## Ashburton - Tinwald Connectivity DBC

**Preliminary Design Stage Road Safety Audit Report**

**Prepared for Ashburton District Council**

REV 0 - JULY 2022

**Figure 2-1 – Safe System Assessment Summary Scores**

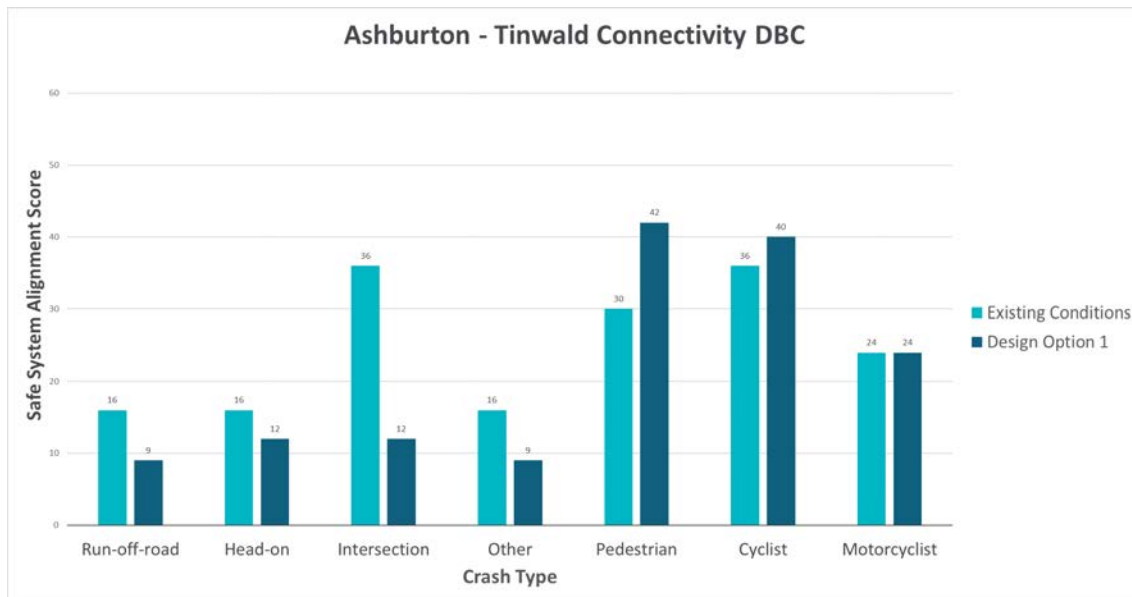
The SSA summary scores for the existing corridor and proposed design can be seen in Figure 2-1. The SSA Matrices are provided in Appendix A.

1. Consider options in the preferred design to reduce the likelihood and severity of crashes involving pedestrians and cyclists, for example treatments to reduce speeds further in conflict areas to less than 30 km/h impact speeds, and provide improvements to pedestrian and cyclist crossing points (i.e. mid-block away from intersections) and overall wider network connectivity; and;
2. Consider other safe system supporting treatments in the design to improve overall safety further;
3. Consider motorcyclists in the design and the need to provide specific motorcycle safety treatments

*Designer Response: Generally Agree with SAT recommendations.*

1. The design has been updated to increase the width of the on-road cycle lanes on sections where on street parking is provided from 1.5m to 1.8m to provide a buffer between cyclists and parked vehicles and reduce the risk of injury for cyclists on mid-block locations. Further opportunities to improve safety for pedestrians and cyclists by extending the facilities outside the direct project area into Tinwald should be explored during the Detailed Design, which includes potential additional mid-block pedestrian crossing facilities. Where there is a large distance between current proposed facilities, most likely between Wilkins and Johnstone as there is 450m between intersection crossing points. At this stage there is uncertainty regarding the nature of future land uses, and location of any additional facilities would need to meet key desire lines (which is partly dependent upon the types of adjacent land use). As such, at this stage no additional mid-block pedestrian refuges have been identified.

Figure 2-4 – Proposed Cyclist Facilities Showing Narrow Shared Path Facilities

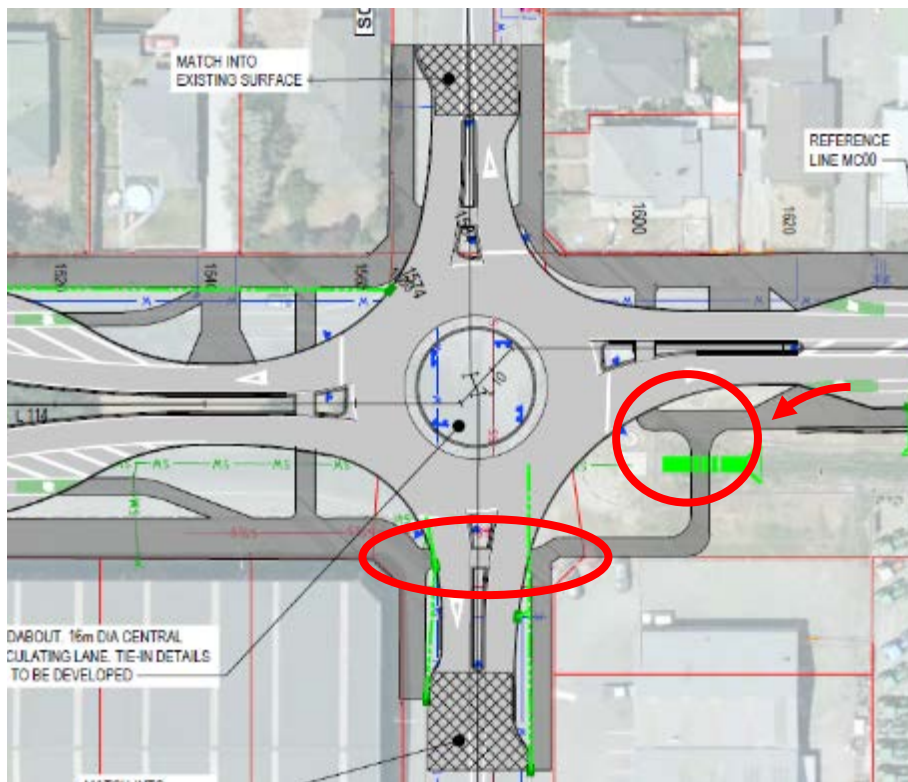
The proposed markings show the on-road cycle lanes ending and transitioning to shared path facilities in advance of the roundabouts. However, the shared path in some places is too narrow and there are no clear markings or signs proposed to communicate the shared facility, as shown below in Figure 2-4.

The crossing points through the splitter islands are too narrow for a shared path and there are no proposed transitions to the connecting local roads. This reduces the overall level of service for cyclists at these key locations and increases the likelihood of conflict with other path users or general traffic at entry / exit points. This reduces the attractiveness of the shared path facilities meaning cyclists are likely to remain on-road.

There will also be a desire to link from the proposed paths to the existing mountain bike trails running adjacent to the Ashburton River.

1. Provide on / off ramp facilities on all legs of the roundabouts, including local side roads
2. Provide dimensions of the shared path and footpath facilities
3. Increase the width and depth of crossing points to accommodate both cyclists and pedestrians
4. Provide typical shared path treatments, including shared path symbols, signs, and green line marking
5. Consider improving cycling connections to local roads at key intersections by providing shared path to on-road transitions
6. Provide clear linkages to the mountain bike trails

**Designer Response:** Generally agree with SAT recommendations

Figure 2-5 – Proposed Cyclist Facilities Showing pinch points on approach to roundabouts

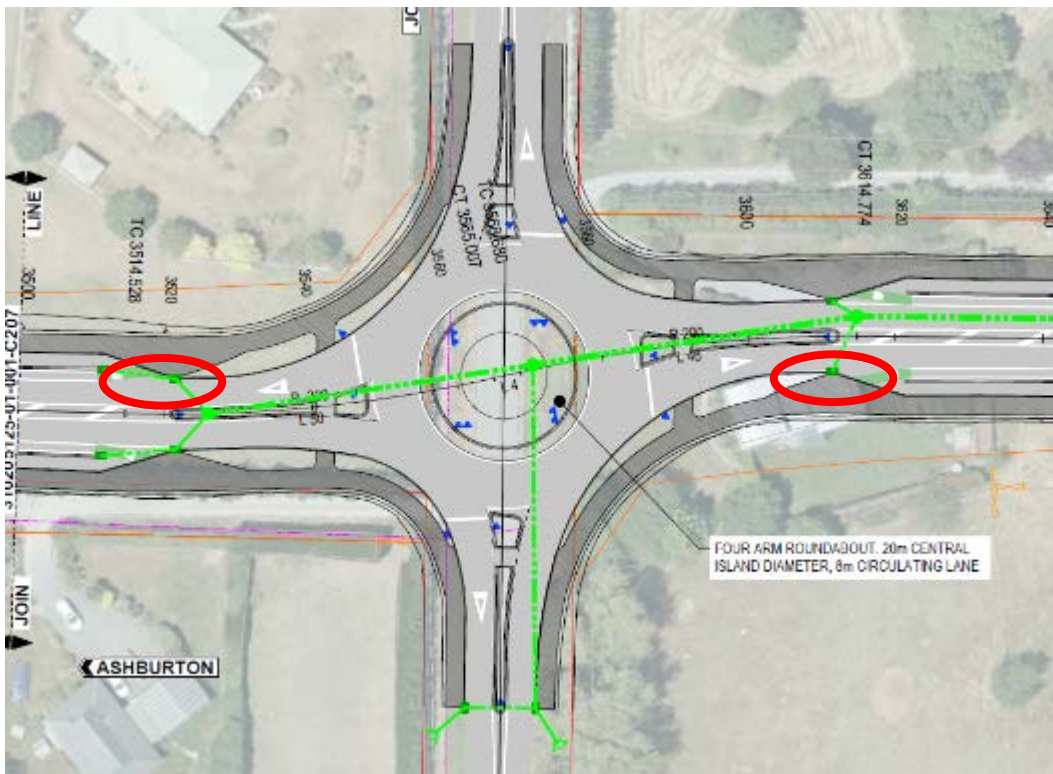
The approach to the roundabouts, show the carriageway narrowing and may squeeze cyclists that remain on-road. More confident cyclists may take the lane, but some may position themselves to the left and without adequate shoulder width or markings, will place them in direct conflict with other vehicles. This increases the likelihood of a conflict between vehicles and cyclists using the intersection, particularly as vehicles track along the inside of the curve and across the path of a cyclist.

The SAT note the on-road cycle lanes transition via a ramp to the off-road path, immediately prior to the intersection. However, the traffic shoulder appears to narrow suddenly, providing little room for on-road cyclists. Refer to Figure 2-5. This may force a cyclist into the kerb or in direct conflict with vehicles approaching the roundabout, resulting in death or serious injury.

**Designer Response:** Partially agree with SAT recommendations

Figure 2-7 – Example of shared path vehicle crossing points

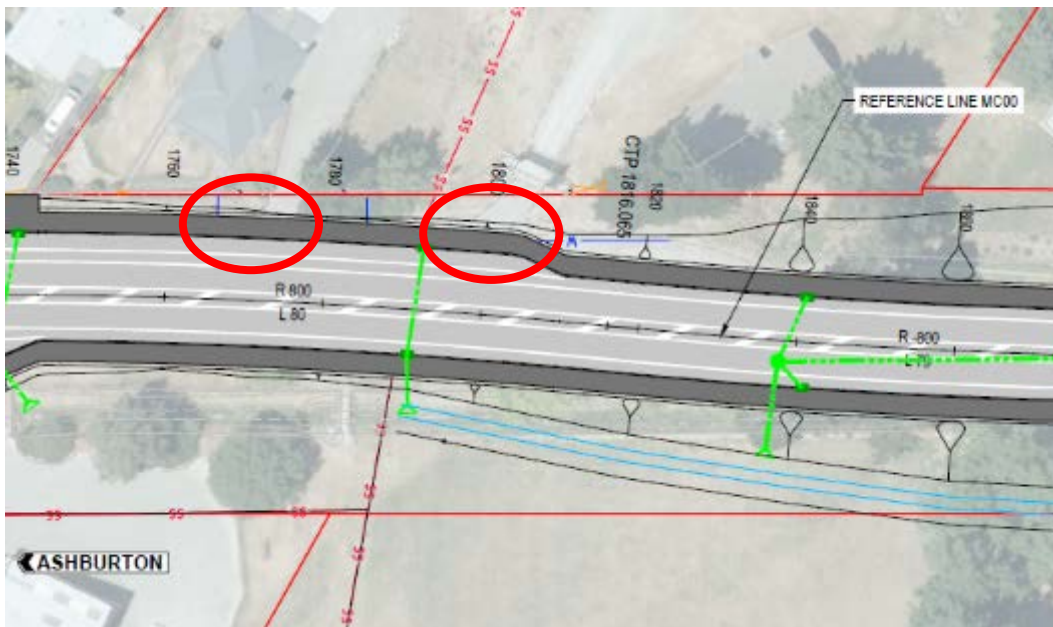
A cyclist or pedestrian being struck by a vehicle entering or exiting one of these accessways has the potential to be seriously injured or killed. This is particularly true for small children on bikes, as they are more difficult to see and are more severely affected by an impact with a vehicle.

Therefore, it is important to provide clear sight lines and control speeds at these critical conflict points. This will be especially true as the land develops and new driveways are created, as path users may be surprised by new conflict points. Line marking and signage should also be used as supportive measures to raise the awareness for motorists and other road users to expect to encounter pedestrians and cyclists.

1. Provide clear sight lines at shared path vehicle crossing points, particularly those with high expected turning movements
2. Consider additional speed controls at vehicle crossings with high expected turning movements, such as vertical deflection or additional delineation
3. Install shared path line marking symbols at all vehicle crossings and confirm symbols face the direction of the exiting vehicle, as per best practice design guidelines

1. At this stage there are no plans for high (or even moderate) trip generating activities to be introduced that would have direct access onto the corridor. ADC are at the initial planning stages for how land use along the corridor could develop in the future. The vertical and horizontal geometry generally does not create any restriction on sight lines to / from private accessways and the shared paths. In the most part there is clearance provided between the private property boundaries (possible fence locations which will restrict visibility) and the back of the shared paths, meaning visibility is maintained. Additional guidance through the District Plan may be required to enforce fence height and setback requirements for Urban private accessways adjacent to shared use paths, current guidance is mainly focussed on Rural accessways.

2. To be considered and developed during the Detailed Design phase, once adjacent land use is confirmed and high demand accessways are identified.
3. Additional markings to be considered during Detail Design Phase to highlight shared path crossing points with private accessways.

Figure 2-8 – Pedestrian and cyclist crossing facilities at roundabouts (high speed exit locations circled)

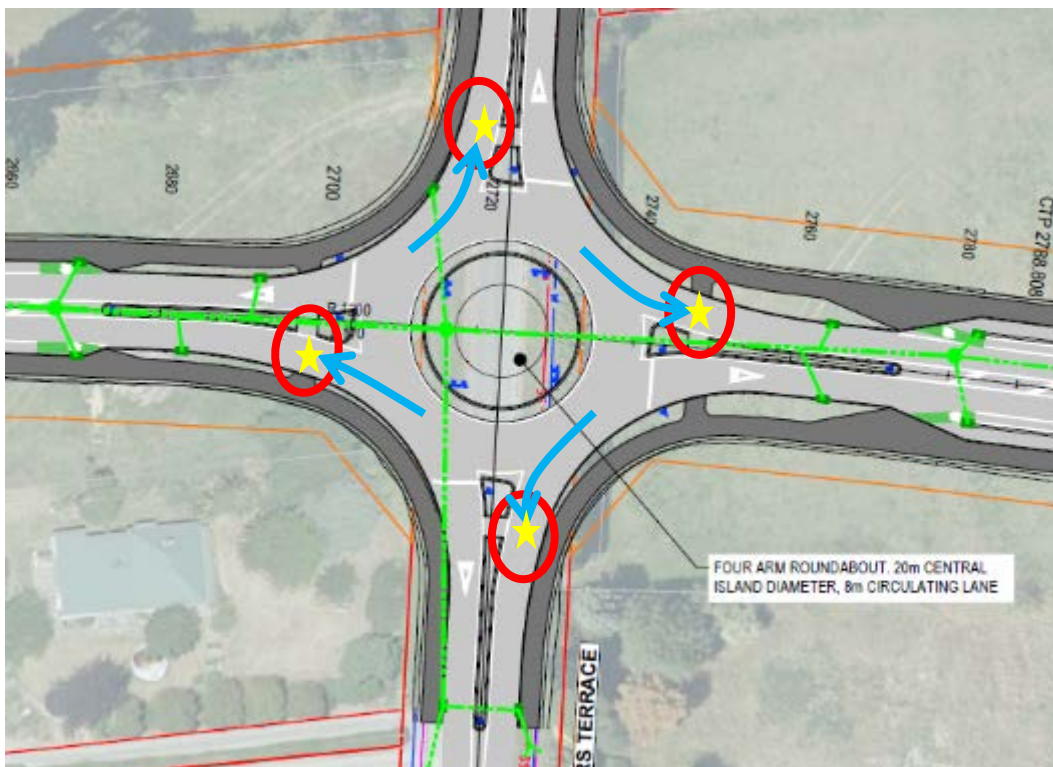
Whilst the entry speeds of vehicles approaching the roundabout are likely to be lower than 50 km/h (as they prepare to give way), speeds are likely to be approaching 50 km/h as vehicles exit from the roundabout. If a crash were to occur with a pedestrian or cyclist crossing at the roundabout exits, it is possible to result in a DSI crash as impact speeds are likely to be above survivable speeds of 30 km/h for vulnerable road users. Refer to Figure 2-8.

Furthermore, more confident cyclists will typically 'own the lane' by cycling in the middle of the lane and have cars follow them on approach and around the roundabout. However, cyclists can be difficult to see by some drivers and fail to give way to cyclists using the roundabout. If entry, exit or circulating speeds of vehicles are too high, then any impact with a cyclist in the lane will likely result in a DSI.

3. Excluding the section between South Street and Carters Terrace, which has limited potential for adjacent development and therefore likely to have limited crossing desire, other than to access the river trails. The future adjacent development is going to govern where any additional midblock crossing points will be required. ADC are at the initial planning stages for how land use will be designated, at which point additional crossing points may be considered. To be developed during Detailed Design Phase.

Figure 2-9 – Areas of narrow landscaping adjacent to carriageway and paths at roundabouts

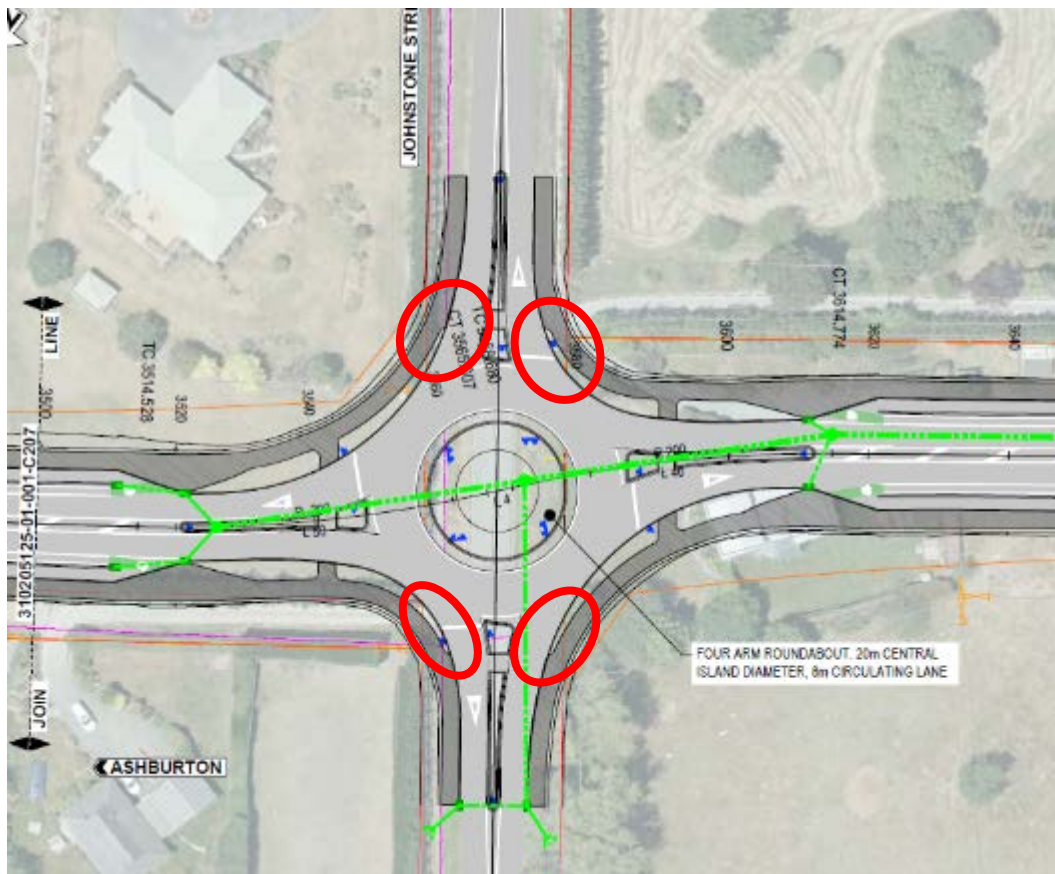
Also to note is any feature / structure could be a distraction for drivers, resulting in failure to give way, with subsequent side impact and rear-end crashes. Any landscaping or structure will require maintenance. This needs to be considered in terms of safety in design for maintenance workers, exposed to the risk of live traffic.

Furthermore, there are narrow strips shown between the carriageway and proposed footpaths on all the rural roundabouts. Refer to Figure 2-9. These areas will be difficult to maintain i.e. narrow mowing strip and will expose workers to the risk of adjacent live traffic. These locations are also critical for maintaining sightlines at the intersection and therefore any planting needs to be low rise.

1. *Ensure any landscaping or structures located within the roundabout central island are frangible, non-distracting and are low maintenance*
2. *Provide low maintenance landscaping on the corner spays of roundabouts, preferably making these hardstand areas*
3. *If landscaping is provided on corner splays, ensure this is low-rise and does not impact with intersection sightlines*

1. *Central islands will typically be hardscaped to remove the need for ongoing plant maintenance within the central islands. Final design treatment to be developed during Detailed Design Phase.*
2. *These areas between the kerbs and shared paths, are to either be grassed, low planting, or hardscaped with a contrasting surface finish. No final decision has been made. To be developed during Detailed Design Phase as per the Landscape and Urban Design Framework*
3. *Due to the requirement for sightlines, if these areas are to be planted, only low height ground cover plantings, <150mm plant height, should be used.*

**Figure 2-10 – Typical Cross-section through roundabout central island**

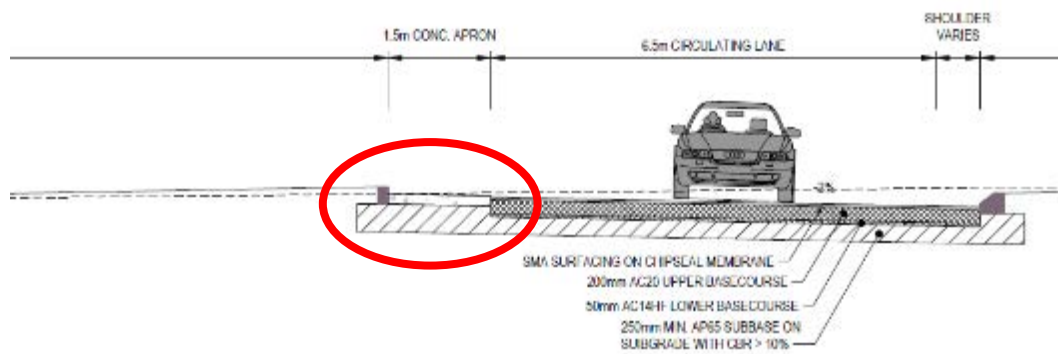
Few details are provided for the roundabout central island, however, it is acknowledged this is likely to be developed further at the next design stage. It appears from the tracking plans and typical cross-sections provided, a concrete apron will be utilised by larger vehicles to track over when turning. Refer to Figure 2-10.

Whilst these areas can benefit larger vehicles, they can increase the speed with which lighter vehicles travel through the roundabout. Furthermore, the kerbed areas around roundabouts can be a hazard to motorcyclists if they are not visible, leading to possible vaulting and loss of control crashes.

1. Final shape, width, and surface finish, of the central island apron will be confirmed during the Detailed Design Phase.
2. The central island kerb will have a mountable kerb type. Typical cross-section drawings have been updated to reflect this.
3. Consideration of motorcyclist safety will form part of the development of the roundabout aprons and overall roundabout form during the Detail design phase.

Figure 2-11 – Typical cross section

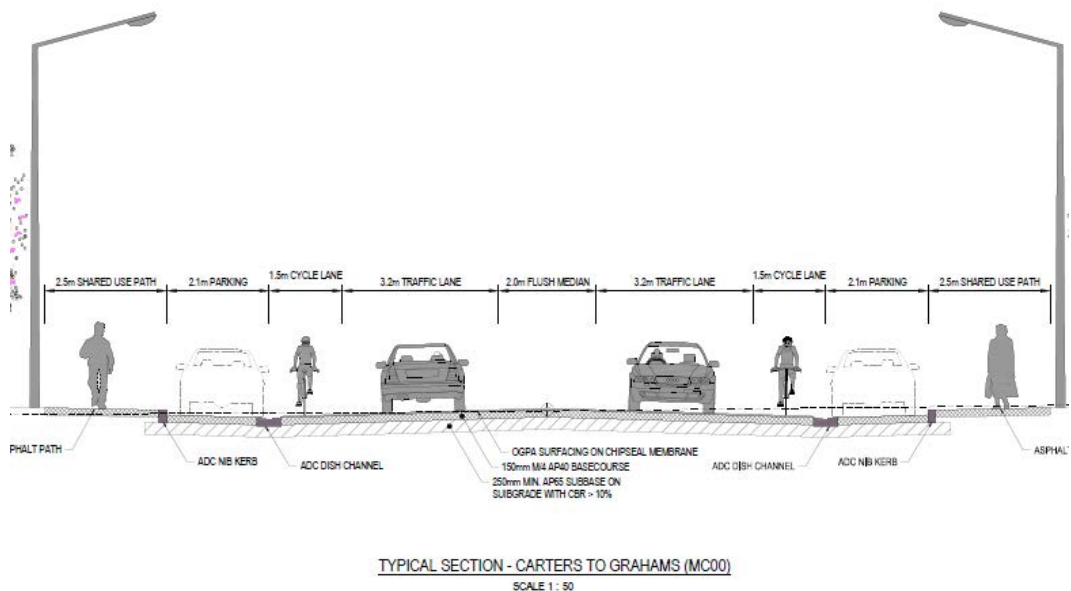
Typical cross-sections were provided for varying sections of the proposed road. This included: a 3.2 m traffic lane in each direction; 2.0 m flush median (replaced with a 0.6 m wide centreline across the bridge); 1.5 m cycle lane (with 1.7 m provided across the bridge); 2.1 m parking lane (or planted berm); and, 2.5 m shared path.

Regarding the 1.5 m wide on-road cycle lane, the SAT raise the following issues:

- With only 2.1 m of parking width provided and long lengths of kerbside parking proposed, there is increased risk of “dooring” issues with drivers exiting cars and cyclists colliding with doors
- The section from Carters Terrace to Grahams Road proposes a dish channel between the parking areas and cycle lane. This area can become trapped with gravel and other material, reducing the effective width for cyclists
- It is unclear why a 1.7 m wide cycle lane is provided across the bridge and 1.5 m in all other places

1. The width of the cycle lanes has been increased to 1.8m where adjacent to parking to provide additional buffer between cyclists and parked vehicles.
2. Parking areas may be reduced by the inclusion of more planted berm areas when the adjacent land activity is known. To be developed during the Detailed Design phase.
3. The 1.7 cycle lane across the bridge is provided due to the potential for a variable height “step down”, potentially up to 60mm, from the final asphalt level to the bridge deck and provides slightly more room over the structures, where a narrower wide centreline instead of flush median treatment is proposed. To be considered further at detailed design stage.

Figure 2-12 – Driveways impacted at Wilkin Street

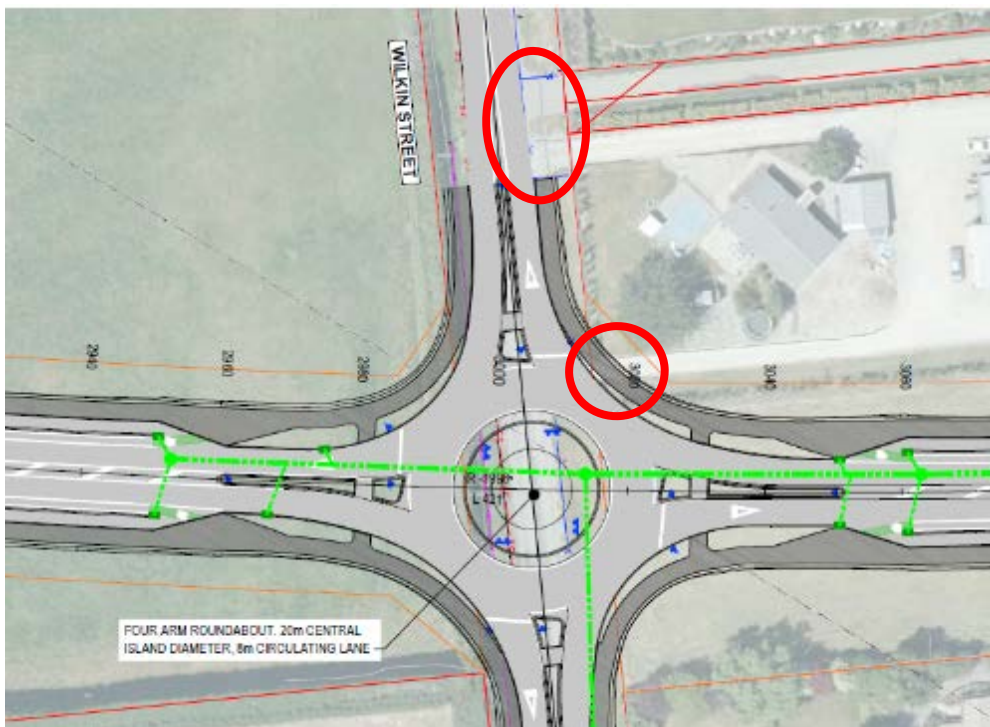
There are a number of existing rural driveways impacted by the proposed road, however, the plans do not detail where future access will be. Some of the existing accesses intersect very close to the roundabouts. Ideally, accesses will be located away from roundabouts to avoid conflict points and confusion.

- Carters Terrace (sheet C205): existing access on the north-west quadrant – it will be difficult to turn right in with the existing splitter island
- Wilkin Street (sheet C206): existing access on the south-east quadrant – one driveway exists at the roundabout. A second access along Wilkin Street will conflict with the end of the shared path. Refer to Figure 2-12
- Johnstone Street (sheet C208): two existing properties on either side of the proposed link road, exit onto Johnstone Road at the roundabout. It is assumed these will have direct linkage to the new road
- Grahams Road (sheet C209): an existing property access is provided through the splitter island (this issued is described further in Section 2.8.3)

Furthermore, given the rural nature of some properties, larger vehicles are likely to be turning in and out. With an increase in traffic volumes and narrowing of some side roads, access points will need further investigation in terms of turning requirements and any additional carriageway widening required.

Rural driveways should also be sealed to avoid excess loose chip migrating onto the shared path or road shoulder, placing cyclists and motorcyclists at increased risk.

1. *Confirm property access points for all affected properties*
2. *Ensure property access is located away from intersections, where possible*
3. *Where access is close to the roundabout, ensure the splitter island length is carefully considered to avoid undesirable u-turn movements*
4. *Undertake vehicle tracking for key accesses, and where required, provide additional carriageway widening*
5. *Seal all rural driveways*
6. *Consider interaction with the shared path for all crossing points*

1. *Additional notes have been added to the drawings, to provide some guidance on interim thinking at accessways to be modified until final adjacent land use is confirmed. To be fully considered at detailed design stage.*
2. *Some property owners have already indicated that they are happy to relocate their access away from the roundabouts but other will be considered / consulted at detailed design stage.*
3. *All accessways will be considered at Detailed Design.*
4. *To be completed at detailed design stage.*
5. *Accessways are proposed to be sealed to the boundary, as per ADC District Plan requirements.*
6. *Response in item 2.3.5 above. To be further considered during detailed design stage.*
